Subject: WPPSS NUCLEAR PROJECT NO. 2
RESPONSE TO QUESTIONS
SACRIFICIAL SHIELD WALL DESIGN

Reference: Letter, W.R. Butler to J.J. Stein, transmitting Request
for Additional Information dated July 8, 1974. (GI2-74-11)

SACRIFICIAL SHIELD WALL DESIGN SUPPLEMENTAL INFORMATION

WPPSS 74-2-R2-ATABLE OF CONTENTS

C = FLOW COEFFICIENT [DIMENSIONLESS]

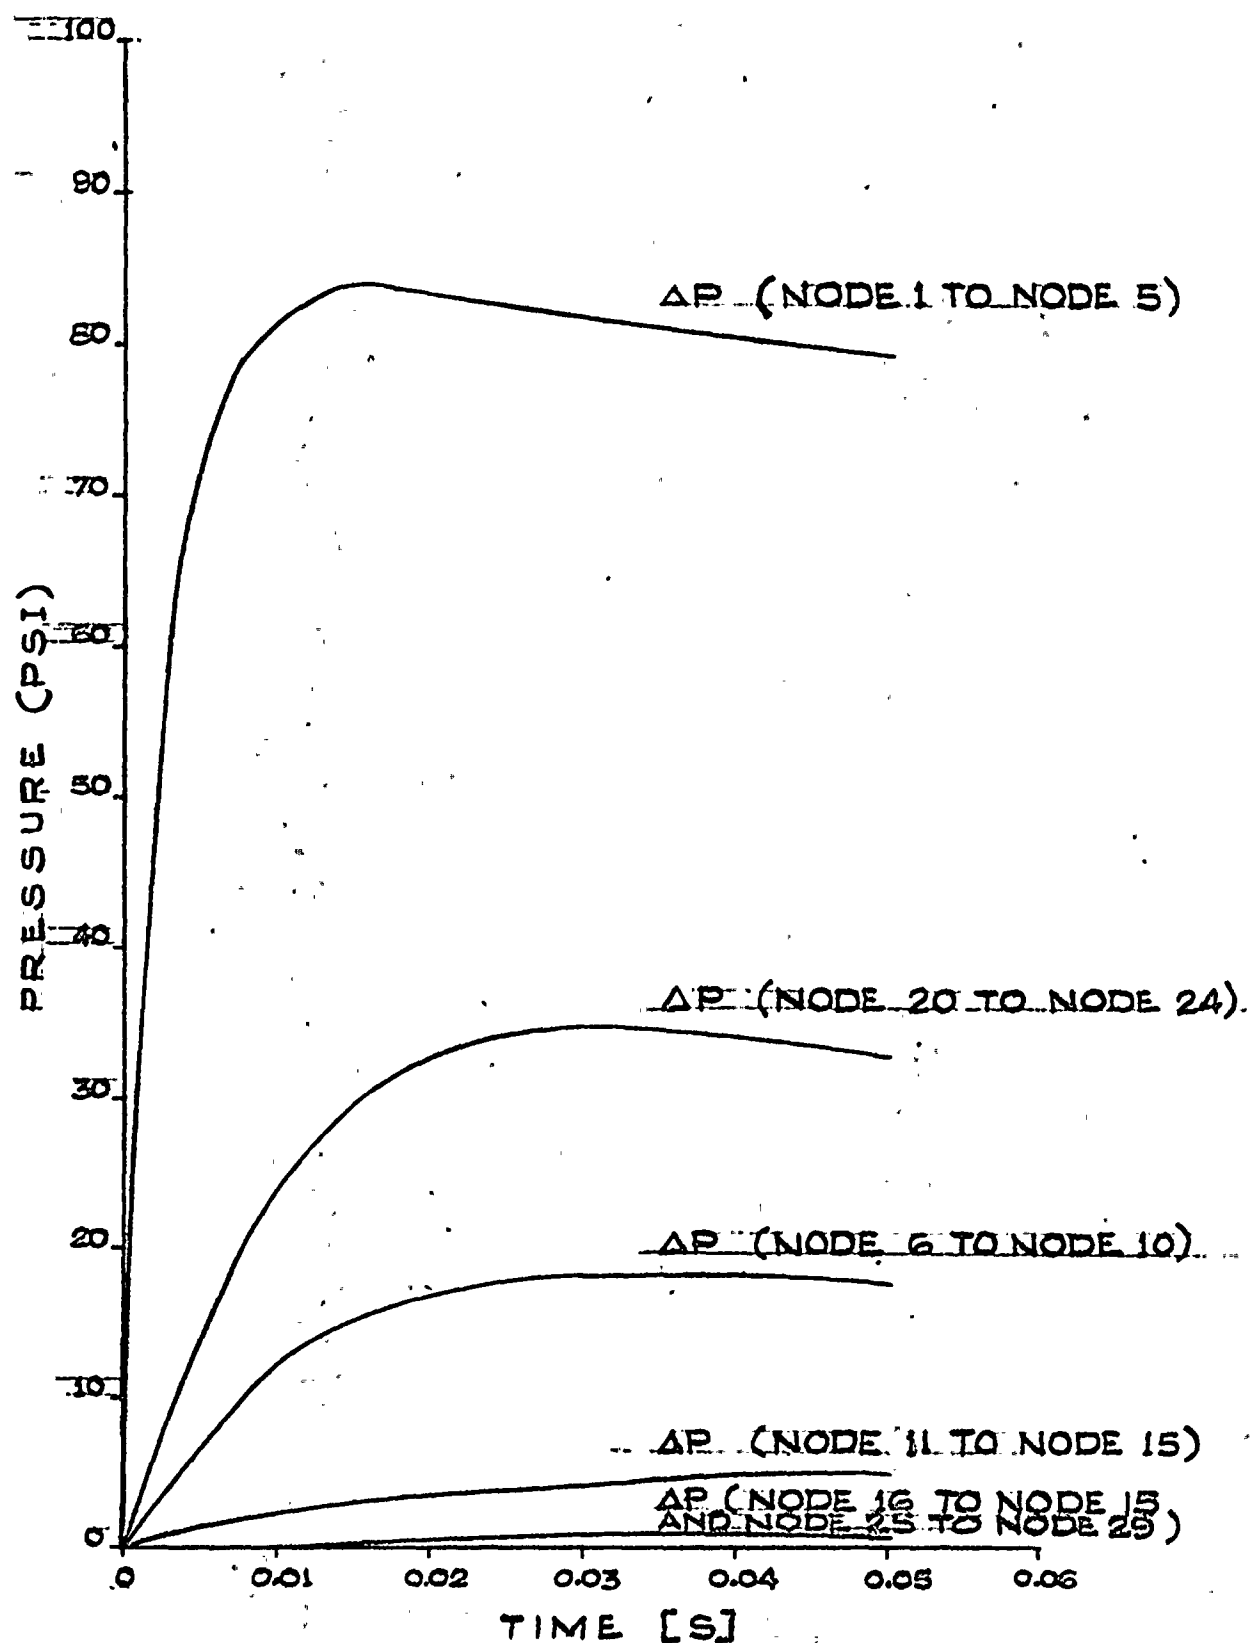
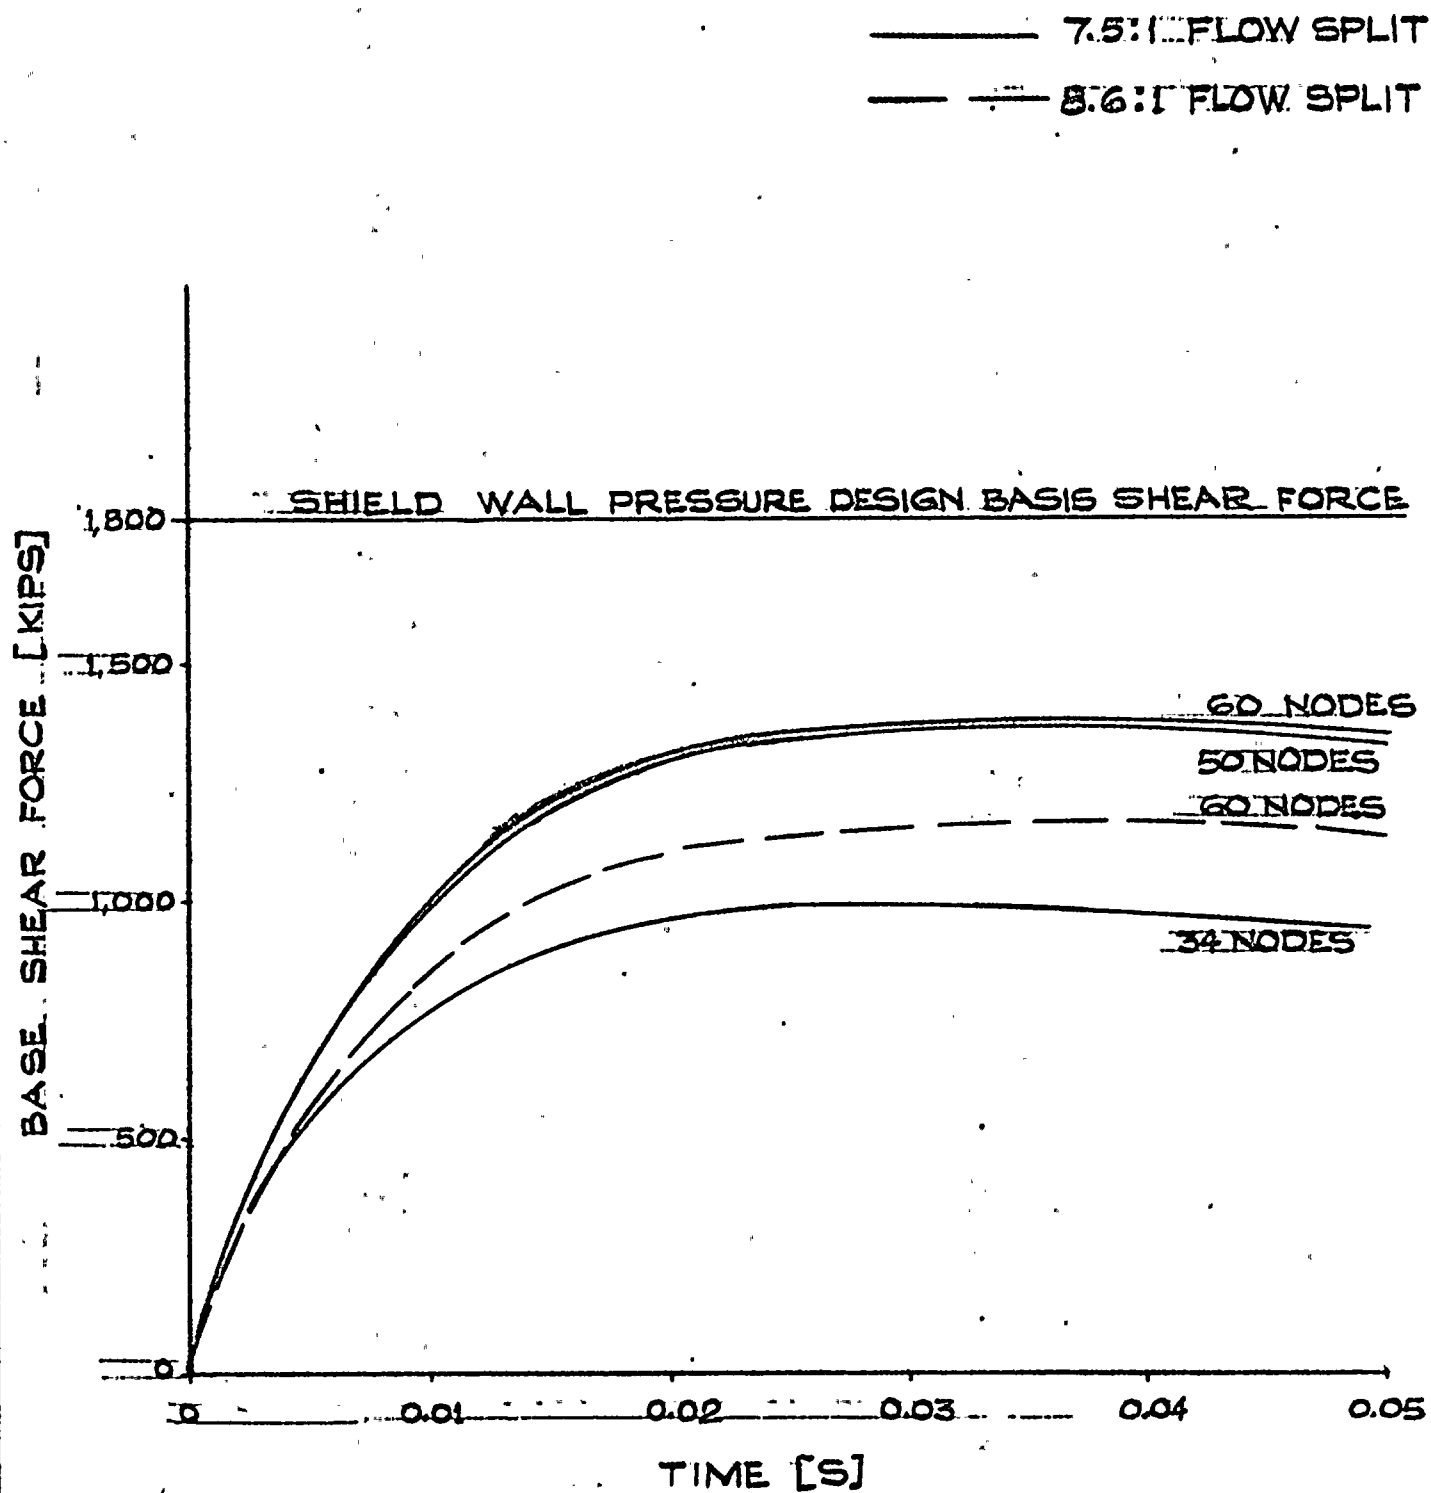
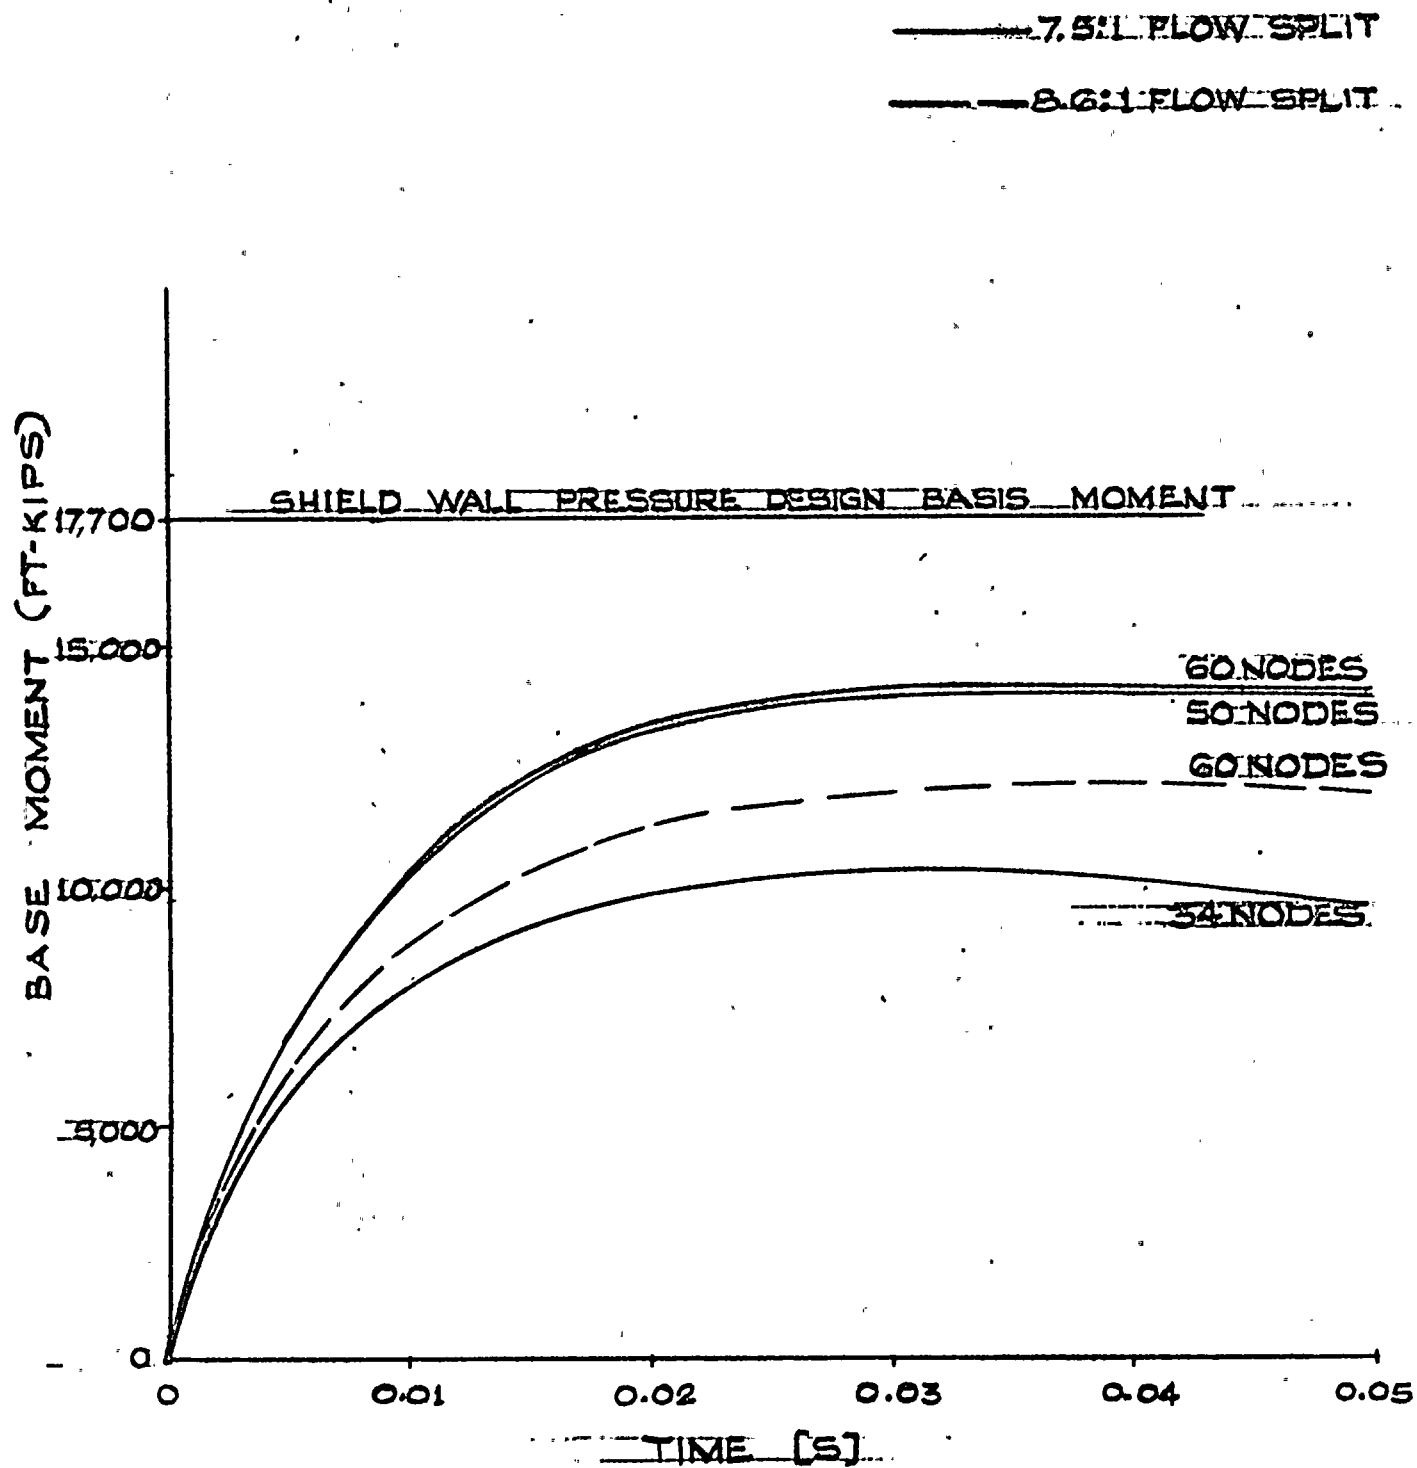
Provide a schematic flow diagram showing the nodalization of the shield annulus and specifying nodal net free volumes and interconnecting flow path areas.

Provide and justify values of vent loss coefficients and/or friction factors used to calculate flow between nodal volumes. When a loss coefficient consists of more than one component (e.g., entrance loss, exit loss) identify each component and its value.

Schematic flow diagrams for the 3 cases discussed in Question 2d are given in Figures 16, 17, and 18. Flow coefficients are also shown for vent areas.

Flow coefficients between nodal volume are shown in the schematic flow diagrams, Figures 16, 17, and 18. The equation used to establish the flow coefficient between nodal volumes is discussed in the response to question 1a (See equation 8).

Within the annulus, for example between node 8 and node 9, the friction loss coefficient is used to establish the flow coefficient since no contraction or expansion loss occurs. The friction loss coefficient is determined from reference 3 based on the hydraulic diameter between nodes and the path length from the center of one node to the center of the adjacent node.

From the annulus to the drywell (e.g., node 18 to node 30 in the 60 node case) the flow coefficient will consist of three terms - an expansion loss coefficient, a contraction loss coefficient, and a friction loss coefficient. The expansion loss coefficient and the contraction loss coefficient are conservatively taken as 1.0 and 0.5 respectively as given in reference 3. The friction loss coefficient is determined from reference 3 based on the hydraulic diameter of the node in the annulus (e.g. node 18) and the path length from the center of the node in the annulus (e.g. node 18) to the drywell.

For flow across elevation 527' (e.g., node 22 to node 27 in the 60 node case), the flow coefficient will consist of two terms - an expansion loss coefficient and a friction loss coefficient. The expansion loss coefficient is a function of the hydraulic diameters as given in reference 3 for a sudden enlargement. The friction loss coefficient is determined from reference 3.
